ST. TAMMANY PARISH
MICHAEL B. COOPER
PARISH PRESIDENT

Addendum No.: 1

Bid#: 23-27-2

Project Name: STAC PHASE IV – BEAUTIFICATION LANDSCAPE WORK

SHEET NUMBER	
PARTIAL	
FEDERAL PROJECT	
STATE PROJECT	
DESIGNED	
CHECKED	
DATE	2011
DRAWN	
CHECKED	
R/D	
DATE	2011
SHEET	
BY	
REVISION DESCRIPTION	
NO.	
DATE	
NO.	
PLANTING DETAILS	LD - 01
LANDSCAPE DESIGN

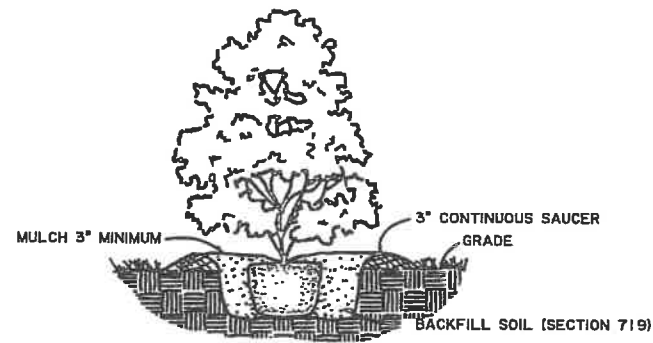
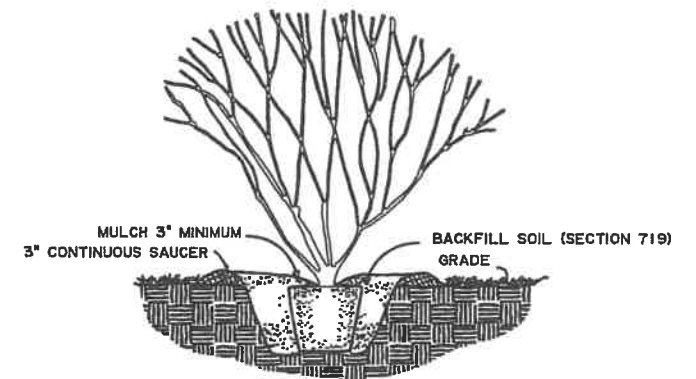
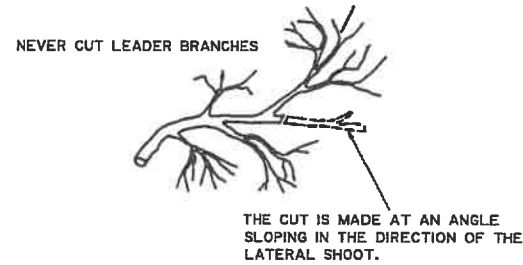
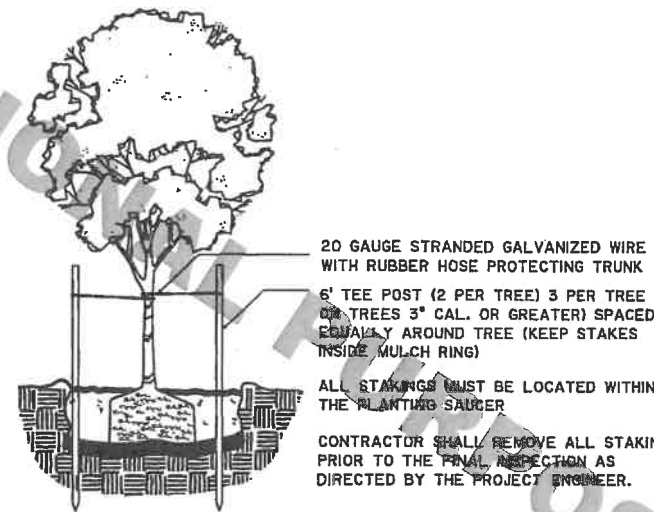
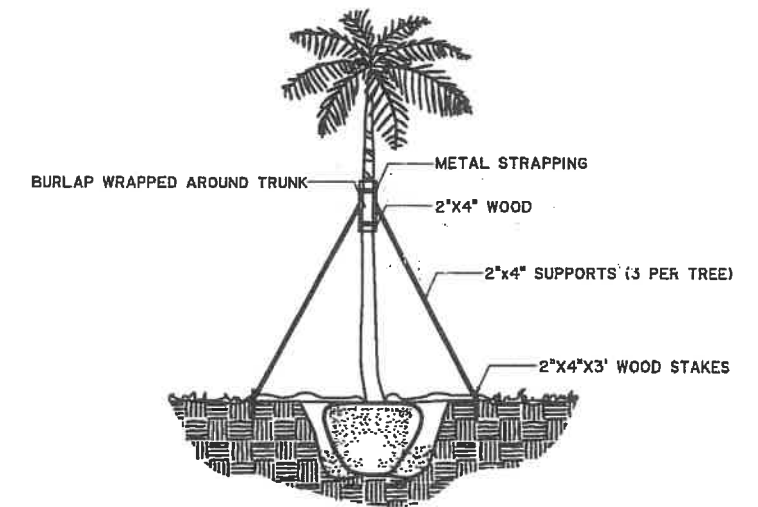
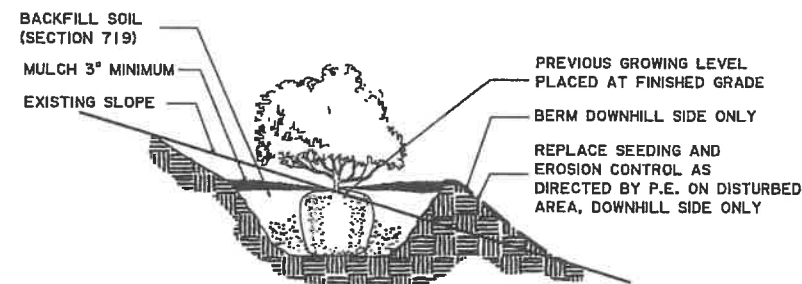
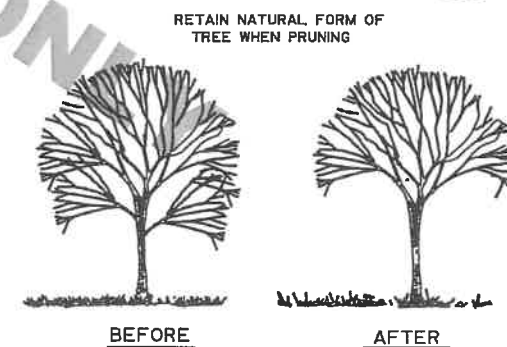
Question 6: There seems to be no planting details within the plan set. Will these be given?

Answer 6: See sheet L7.00 which indicates State Detail LD-01 is to be used. LD-01 is attached for reference.

CB-01 (BRICK OPTION)

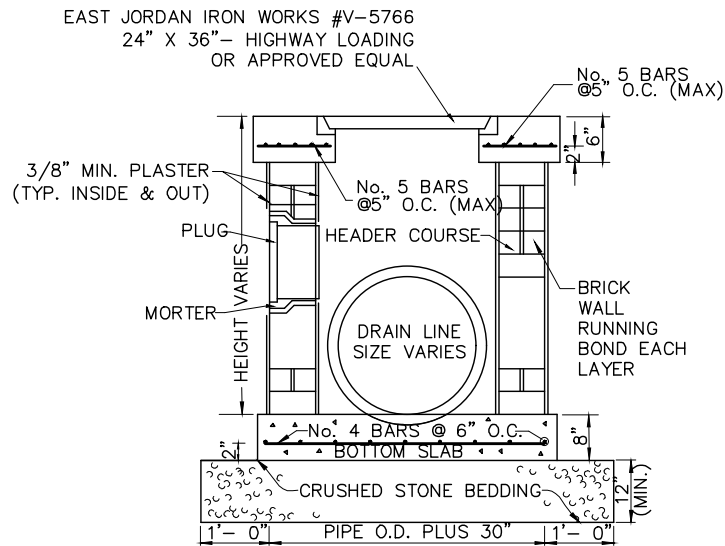
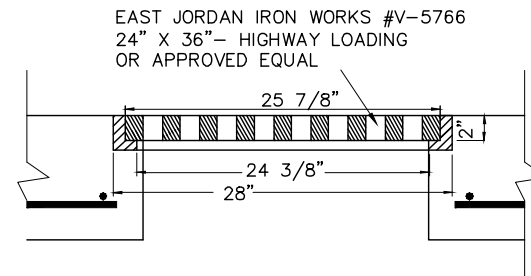
Question 7: Will St. Tammany Parish allow Item Catch Basin (CB-01) to be installed as brick catch basins.

Answer 7: The Parish will allow the Contractor to install catch basins as brick Catch basins. Brick Catch Basin Detail is attached.

1. DRAIN INLET WALLS TO BE 8" BRICK OR PRECAST CB-01 EQUIVALENT FROM LADOTD APPROVED SUPPLIER/MATERIALS LIST.
